Docket Item # 1
BAR CASE # 2011-0352

BAR Meeting
January 4, 2012

ISSUE: Alterations (balcony enclosure)
APPLICANT: Robert and Joan Chase
LOCATION: 1250 South Washington Street #406
ZONE: RC/Residential

Figure 3: Proposed enclosure.

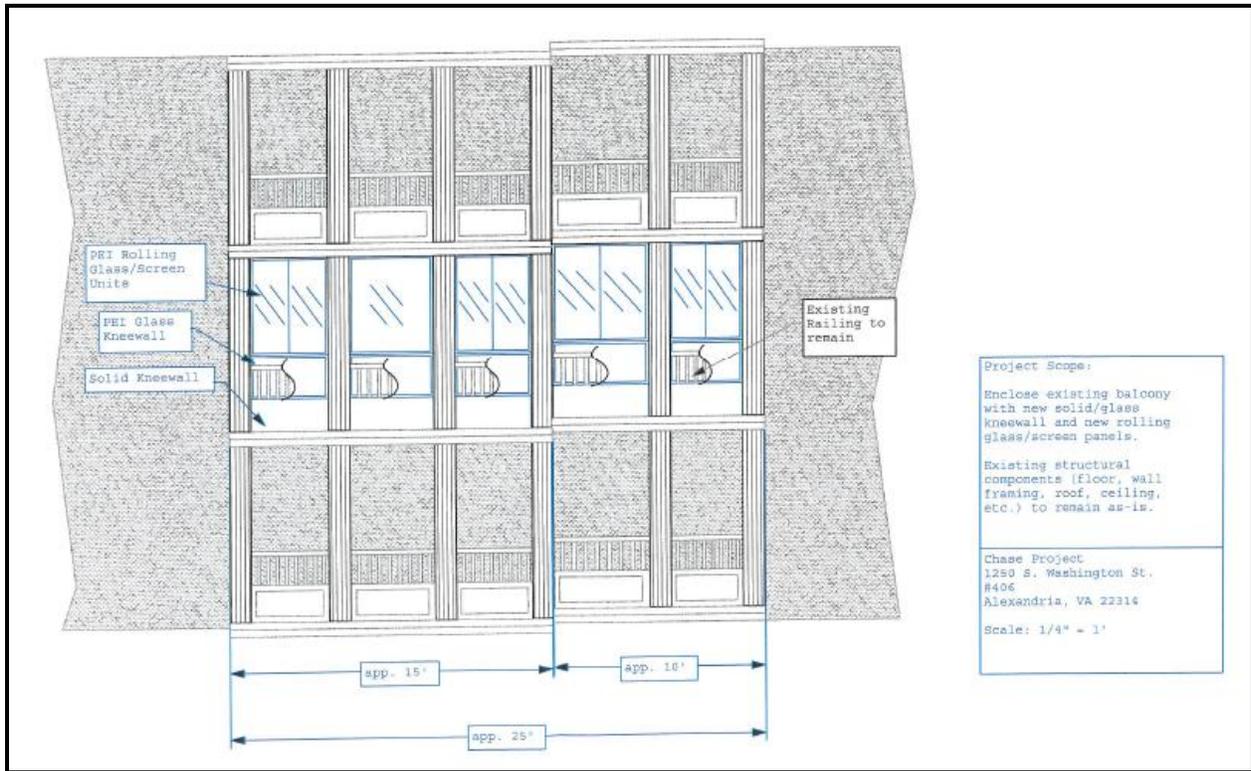
STAFF RECOMMENDATION: Staff recommends approval of the application, as submitted, with the reminder that the glass should not be visibly reflective or tinted.

Staff has no objection to the proposed balcony enclosure, which is stylistically compatible with the other enclosed balconies in the condominium complex. Per the Design Guidelines and the recent Window Policy updates, Staff recommends that the windows be environmentally efficient low emissivity, insulated glass but that the glass not be visibly reflective or tinted.
